**Well Name:** FLORANCE

### Subsequent Report

**Type of Action:** Plug and Abandonment

PLUG AND ABANDONMENT

## Current Schematic - Version 3

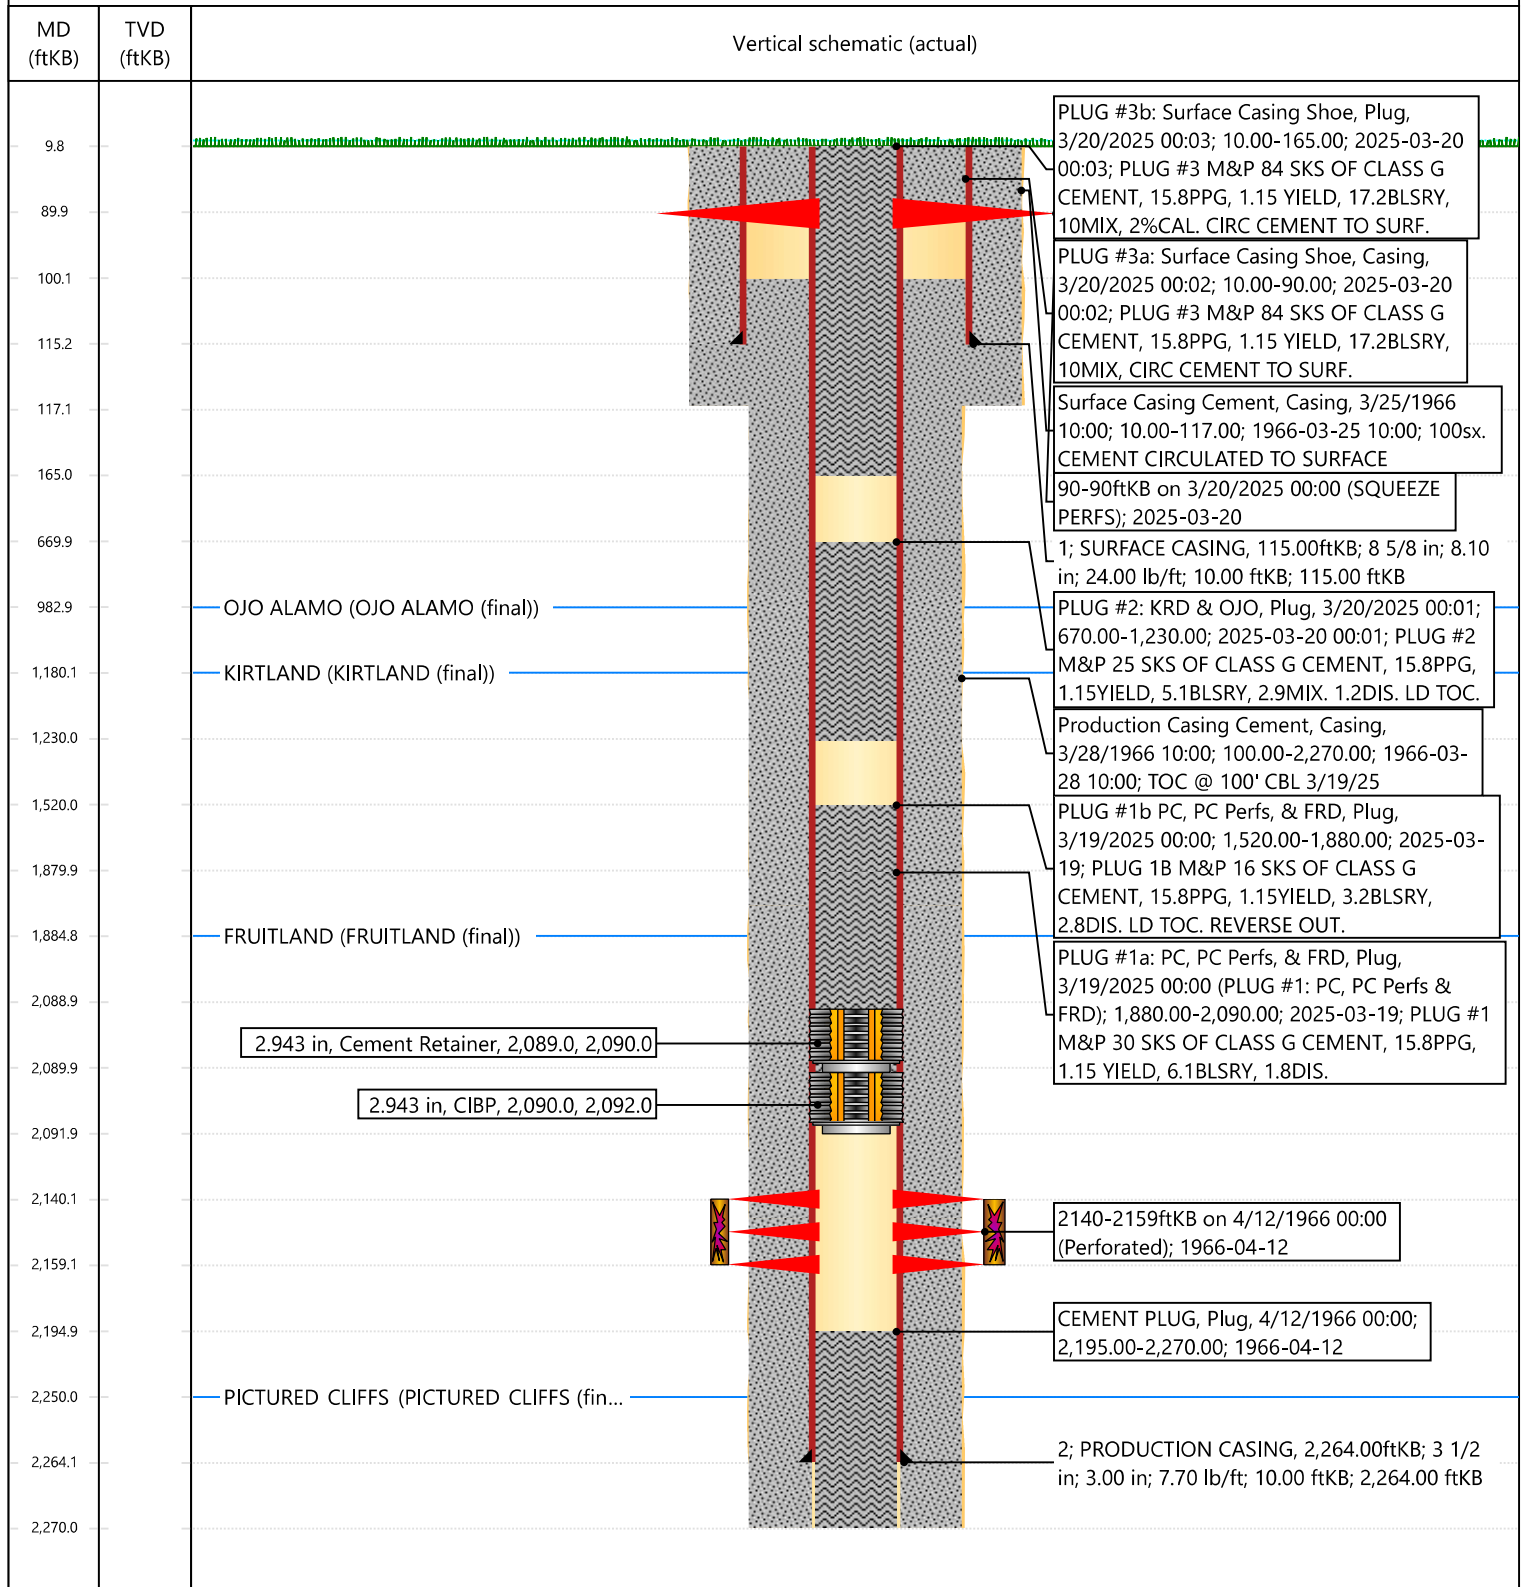
As discussed, we will perforate the surface plug at 90', instead of 165', due to the CBL showing good cement to 90'. We will then run tubing down to 165' and attempt to circulate from there. Whether we circulate or not, we will WOC before cutting the WH and topping off.

As discussed, after tagging plug #1 today at 1,880' and achieving a good pressure test, we will top off plug #1 with an additional 16 sacks to bring estimated TOC to 1,520', not WOC, and then move on to pump plug #2 as planned.

We actually had a discussion on this well this morning. The BLM is requesting that Hilcorp provide cement coverage for BLM selected tops. The Fruitland at 1650 (plug 1 top of cement at 1550) and Ojo Alamo at 820 (plug 2 top of cement at 720).

- The 3-1/2" CIBP originally to be set @ 2,130' will now set @ **2,090'** per verbal approval from the NMOCD & BLM.
- **PLUG #1: 13sx of Class G Cement (15.8 PPG, 1.15 yield); PC Top @ 2,250' | PC Perfs @ 2,140' | FRD Top @ 1,885':**

The BLM approves of moving forward with this plan for the surface plug.

The BLM approves of this plan. If the hole does not stay static after pumping the plug, then Hilcorp will have to wait and tag.

The BLM finds the updated procedure appropriate.
